# City of Sierra Madre

THE FOLLOWING ARE COMMENTS RECEIVED  
FOR THIS MEETING

Re: April 7, 2022 Planning Commission Meeting to begin discussions on the Meadows at Bailey Canyon EIR.

Comments to the Draft Environmental Impact Report (EIR) for the Meadows at Bailey Canyon Specific Plan Project.

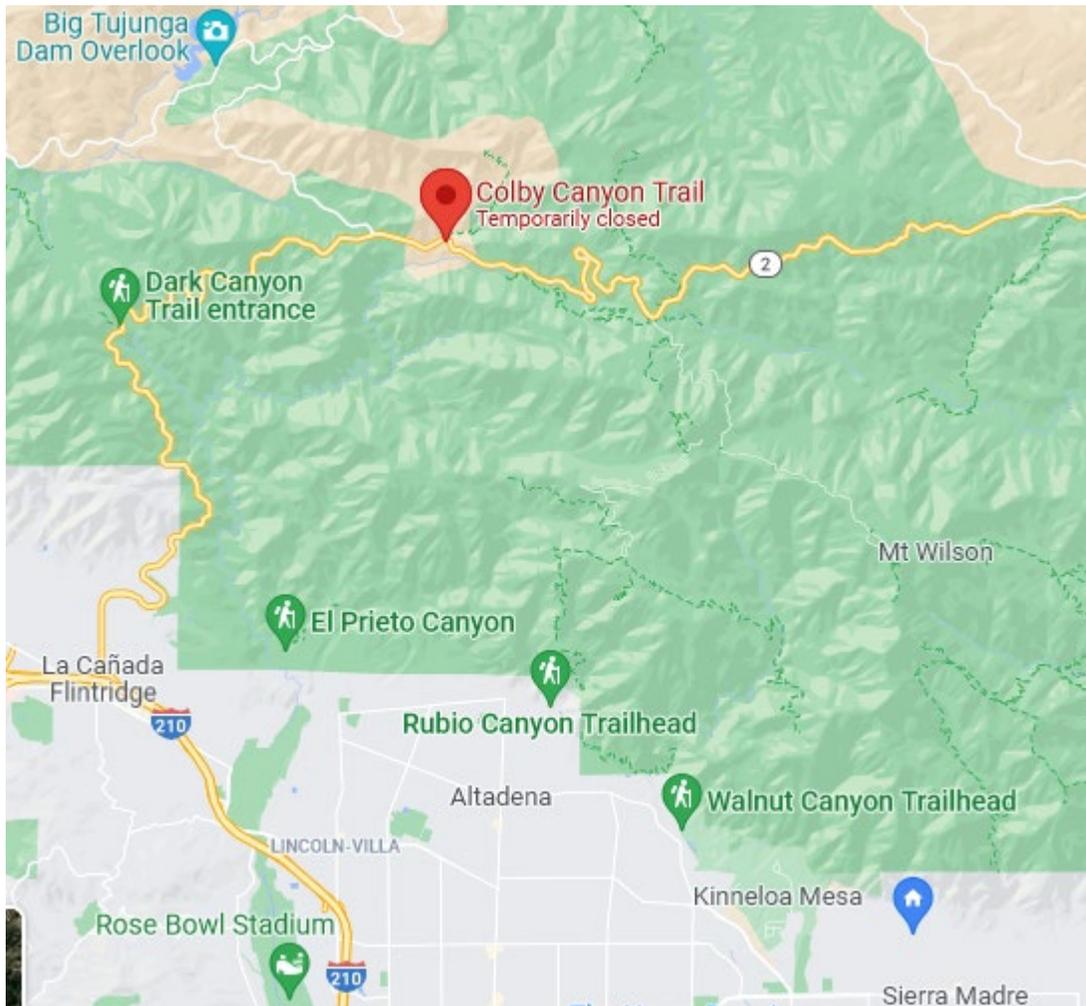
If 3.04 acres of the 3.39 acres is the park, then that leaves .35 acres of open space. Under Project Location above, the area is identified as 35 acres. In project objective number 5, 30 acres is referenced and the area is clearly misidentified as being near Colby Canyon and Colby Canyon Trail. (see Objective 5. Preserve the hillside open space area by dedicating approximately 30 acres north of the Mater Dolorosa Retreat Center to the City, in order to preserve a portion of Colby Canyon and the Colby Canyon Trail, which would be used by wildlife for movement up and down slope; preserve native vegetation communities and drainages; and preserve land adjacent to the Colby Canyon stream). Colby Canyon is above the city of La Canada nowhere near this project. See map below. Thus, the location, boundaries, and acreage of the “open space” are not clear.

Please clearly describe and accurately map the proposed “open space” along with identifying how it will be provided, protected, what its use would be and provide a separate comprehensive environmental review as recommended by MIG. See MIG Review p.3.

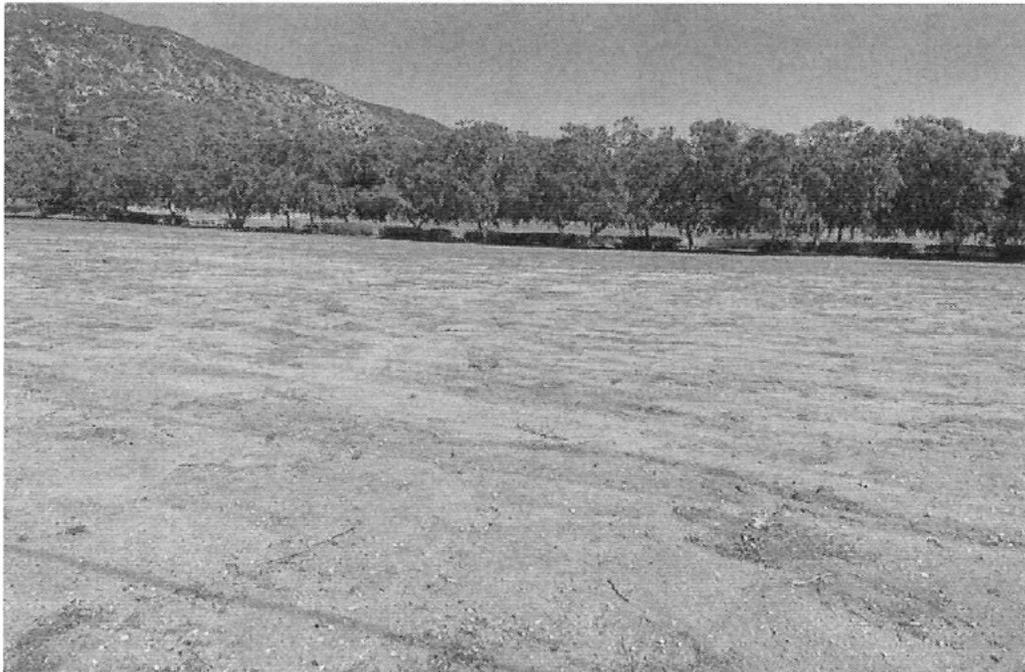
Yes, the Project would block current views of the San Gabriel Mountains from the neighbouring homes on the west and south side of the development. The Project is comprised of a majority of two story homes that would compromise the views that the homeowners now enjoy. The vista from the park area would be minimal as it is the lowest point of the project. When the park trees are mature, they would block visibility to the mountains.
